775 RICHARDS STREET (COMPLETE APPLICATION)  
DE415286 - ZONE CD-1 (Pending)

- **Proposal:** To develop this site with a 46 storey mixed-use building (retail and residential) over eight levels of underground parking having vehicular access from Richards Street.

**DEVELOPMENT PERMIT STAFF COMMITTEE RECOMMENDATION: APPROVE**

A0.01

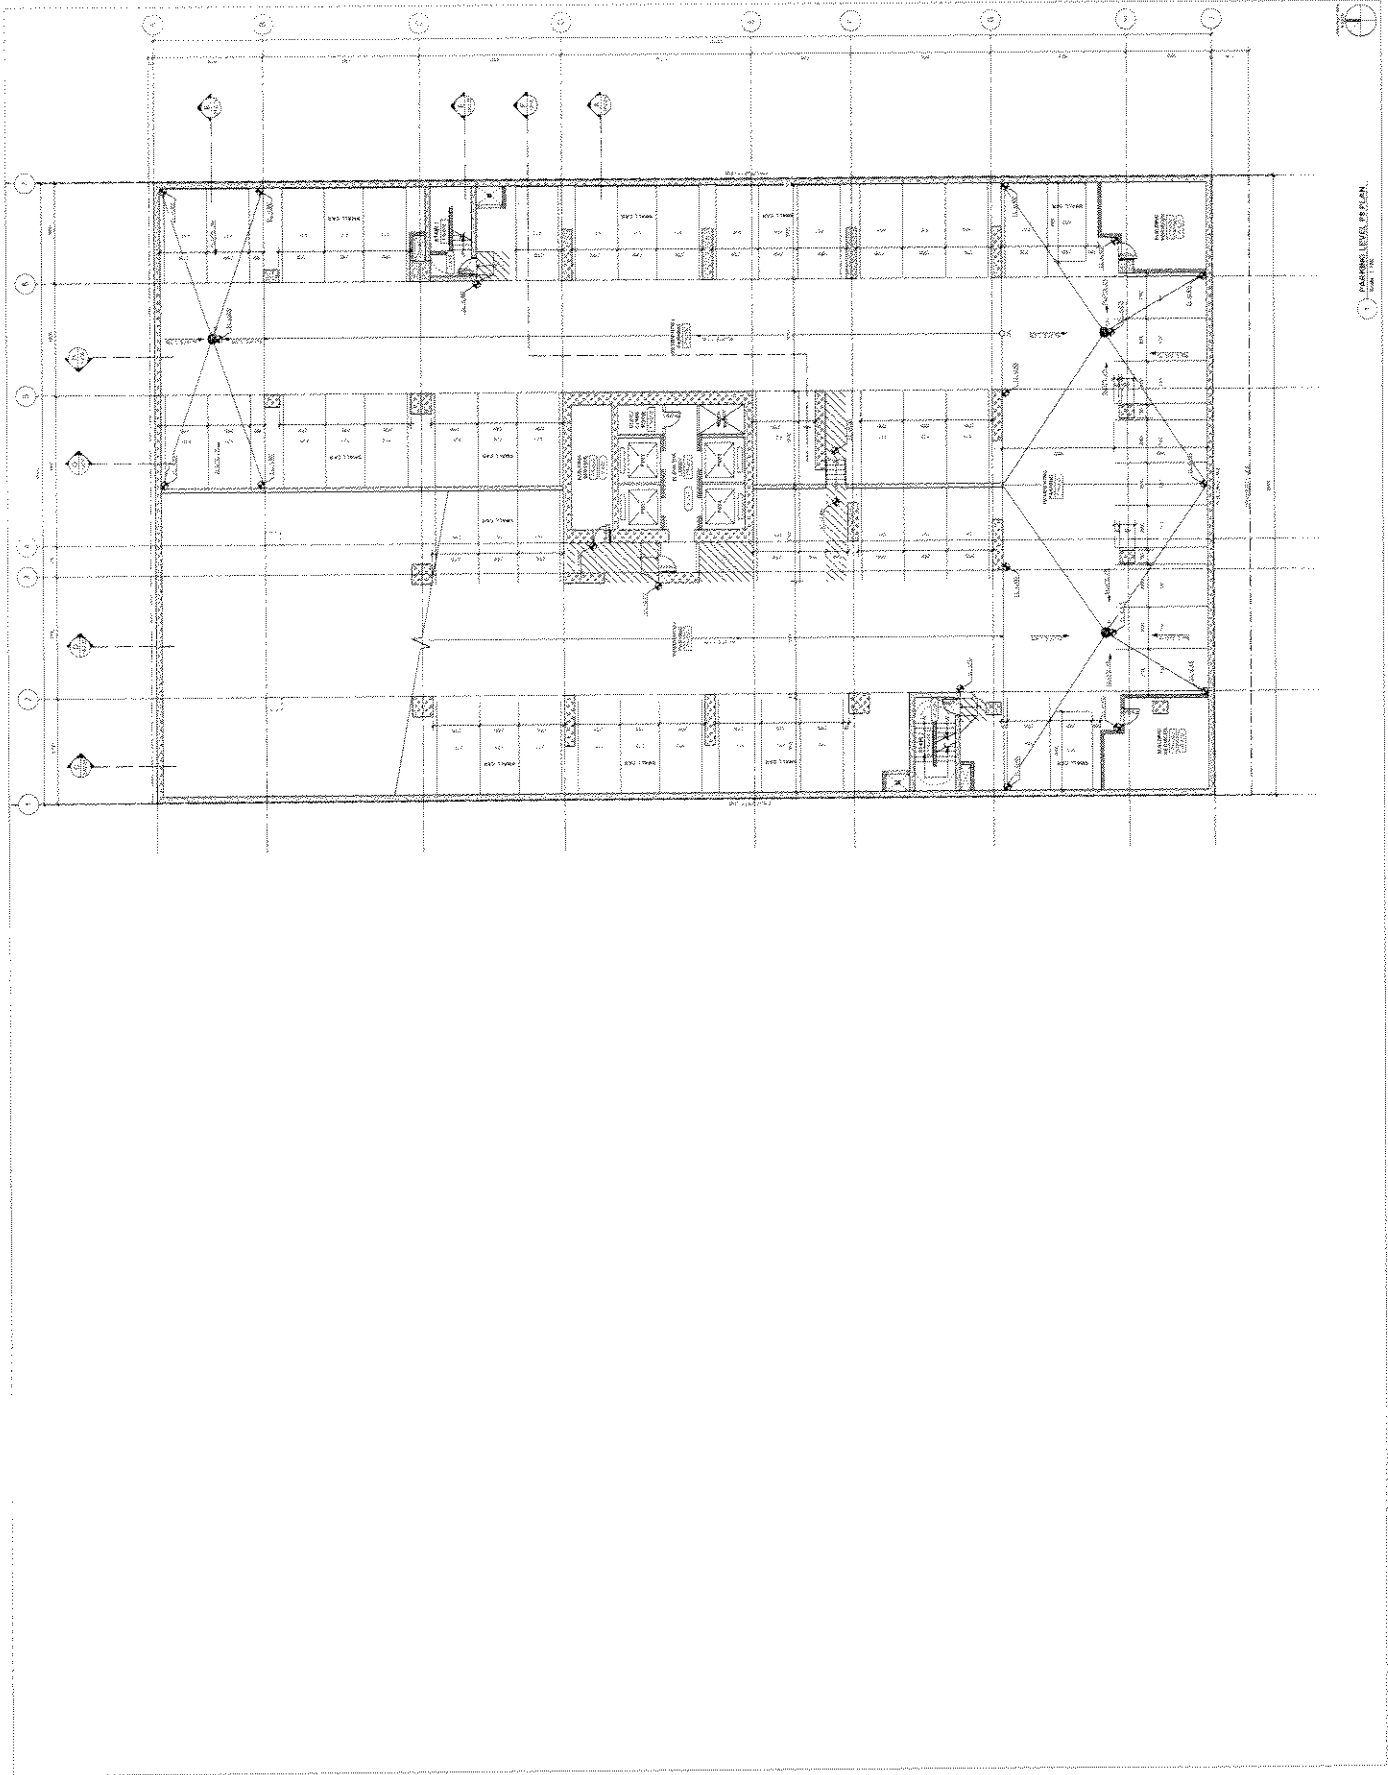
**Note to Applicant:** Sheet A1.00 indicates a setback of 2.146 m from Robson Street. The required road dedication is 2.134 m not 2.146 m.

A1.06

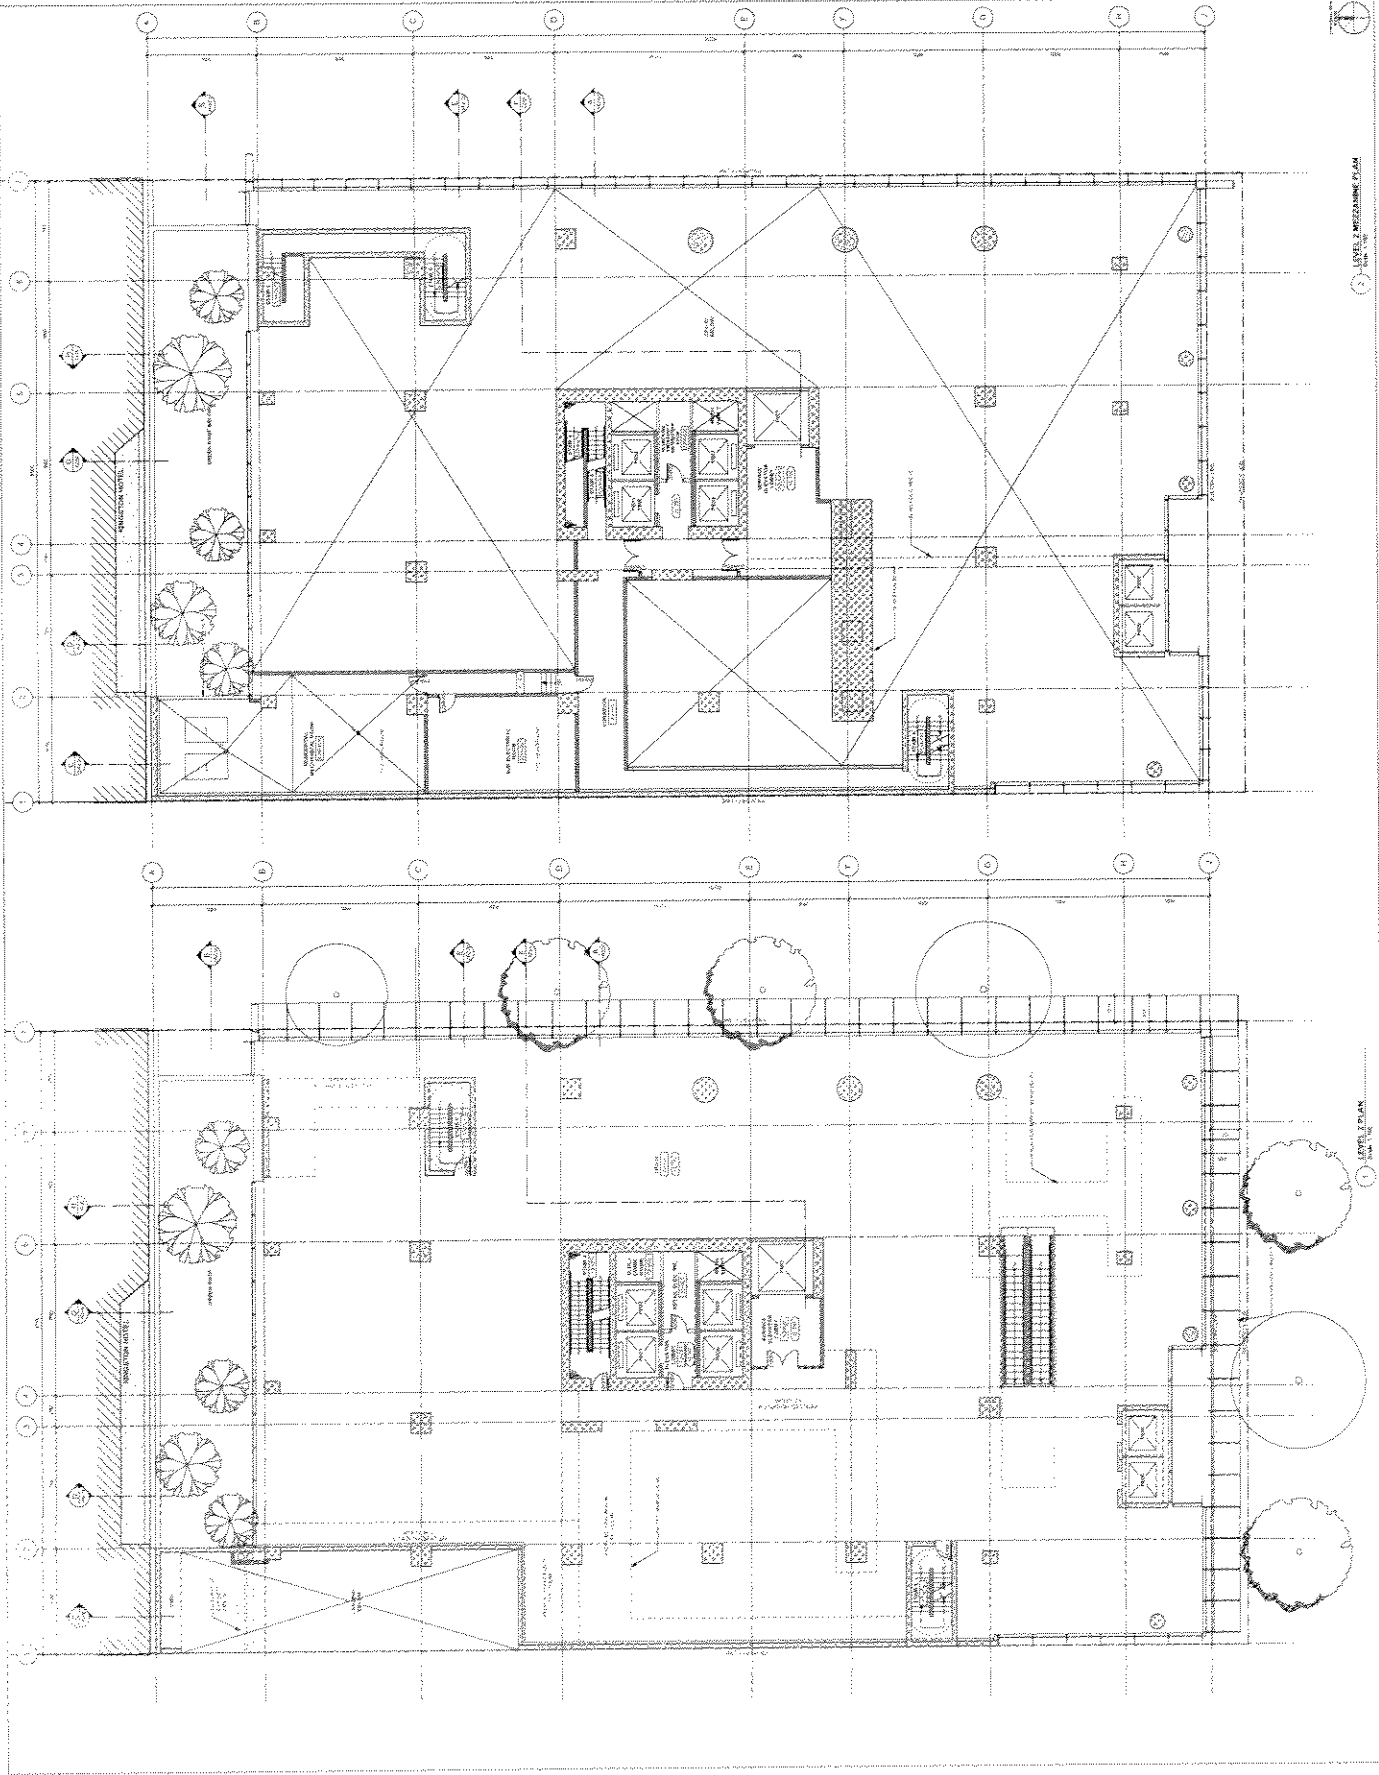
**Note to Applicant:** There are large vertical signs at the 2<sup>nd</sup> and 3<sup>rd</sup> levels at the Southeast and northeast corners over the Robson Street Building line, and the 2.4 m statutory right of way (sheet A1.06).

## Retail Podium—Previous Design

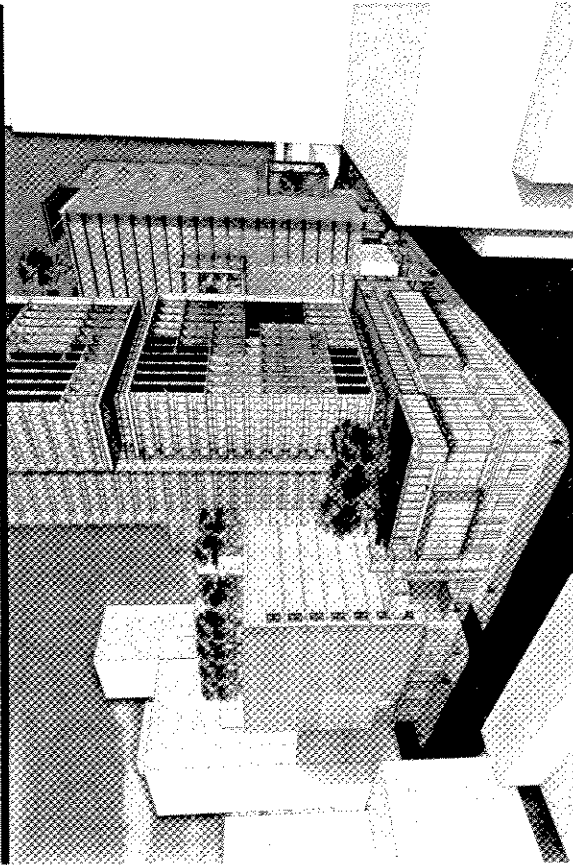
In response to comments from the Rezoning Urban Design Panel regarding the “fragmented” nature of the Residential Retail Podium, the design has been developed to express a unified aesthetic. The simplified form is comprised of a repetitive module of glass and onyx. Visual interest is maintained by the random application of these onyx panels at the second and third storeys. Unlike those on the Office Retail Podium, these onyx panels are slightly angled to provide additional modelling of light and shadow.
